**STATE OF CONNECTICUT  
DEPARTMENT OF ENERGY AND ENVIRONMENTAL PROTECTION  
OFFICE OF ADJUDICATIONS**

**IN THE MATTER OF** : **APPLICATION NO. 202109451-SDFWQ**  
**80 SEAVIEW AVE., LLC** : **JANUARY 30, 2026**

**HEARING OFFICER REPORT**

**Connecticut Department of Energy and Environmental Protection  
Structures, Dredging and Fill Permit Application for  
80 Seaview Ave., LLC  
Application No. 202109451-SDFWQ  
Response to Comments  
January 30, 2026 (Corrected)**

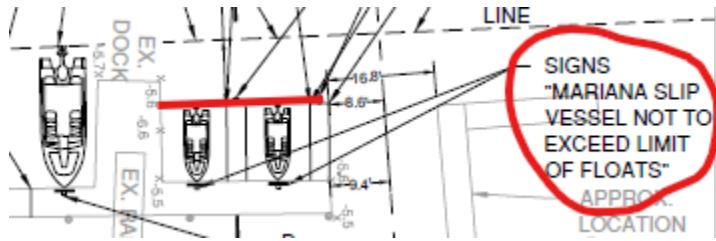
**1. *The pre-existing encroachment of the Applicant's docks into the extended littoral area of the City of Norwalk at First Street on the south side of the Applicant's property is inconsistent with policy 5(c) on page 4-11 in the Harbor Management Plan.***

Although the dock encroachment at this location pre-dates 1980 and was previously authorized pursuant to COP-97-983-KZ, the applicant has agreed to eliminate the floats. The floats and the public transient slips they would have provided will be removed from the final license. The applicant provided the Department with revised plans that show these changes, see Figure 4, below.
